**Proposal #35: 8317-00-70**  
**T Clinton, 17<sup>th</sup> Avenue**  
**Hay River Bridge B030207**  
**Local Street**  
**Barron County**

**8333-00-70**  
**T Sumner, 28<sup>th</sup> Street**  
**Br Rock Creek Bridge B030209**  
**Local Street**  
**Barron County**

### Letting of February 11, 2020

This is Addendum No. 01, which provides for the following:

CROSS SECTION & QUANTITIES  
SHEET 2 OF 8  
25

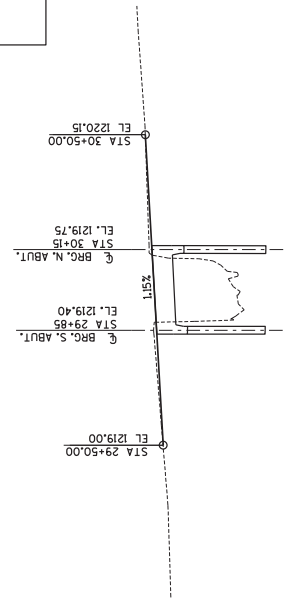
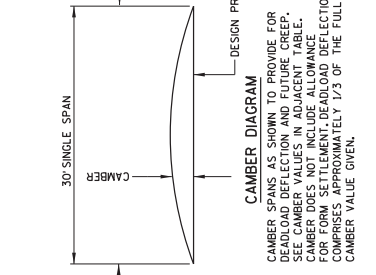
Revised Plan Sheets	
Plan Sheet	Plan Sheet Title (brief description of changes to sheet)
24	Foundation Data
25	Cross Section & Quantities, Structure B-03-0209 – Removed 550.0200. Revised 550.1100
27 – 28	Adjusted Pile length

NO.	DATE	REVISION	BY
1	2/6	REMOVE PRE-BORING	MJG

DESIGNED BY: J. W. B. / J. W. B.  
 DRAWN BY: J. W. B. / J. W. B.  
 CHECKED BY: J. W. B. / J. W. B.  
 SHEET 4 OF 8  
 DETAILS

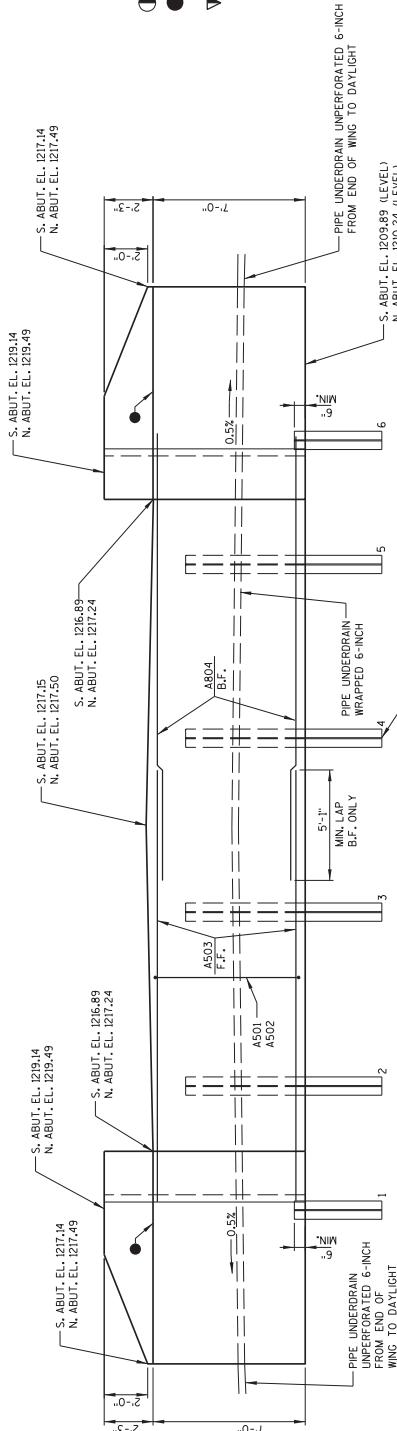
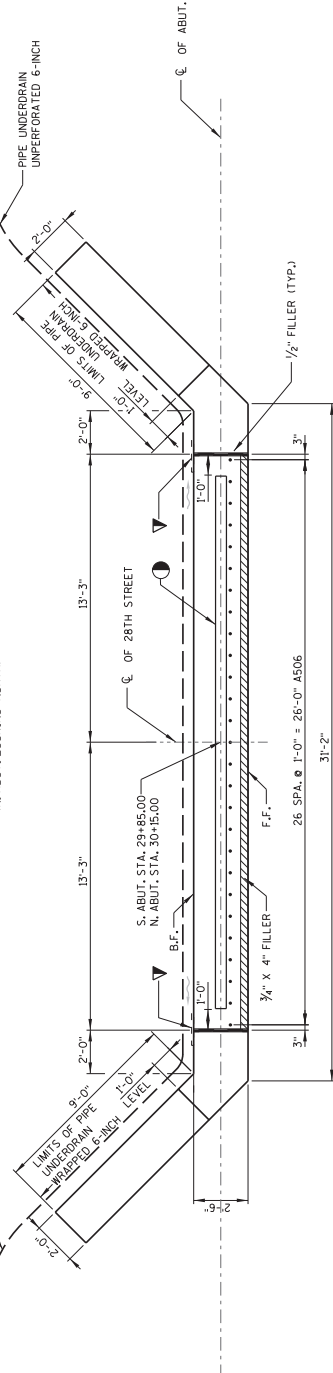
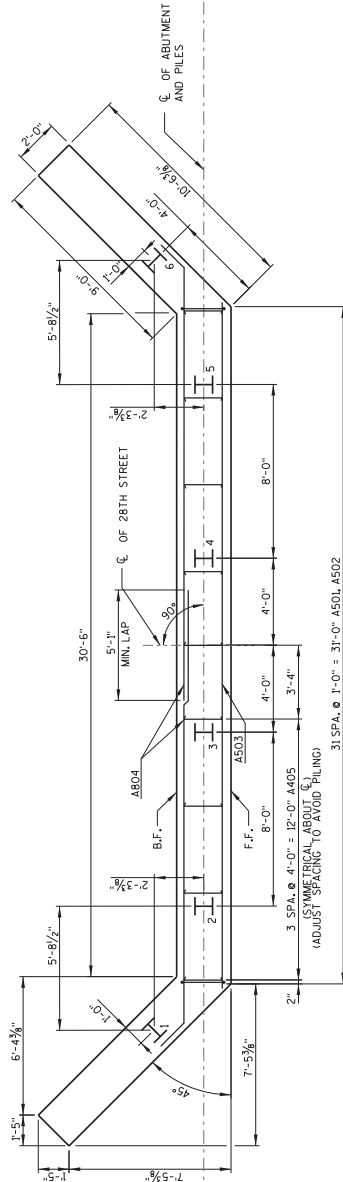
NO.	DATE	REVISION	MIG
1	2/6	REDUCE PILE LENGTH

21" LONG DRIVEN TO A REQUIRED  
 PILE AS DETERMINED BY THE MODIFIED  
 GATES DYNAMIC FORMULA.
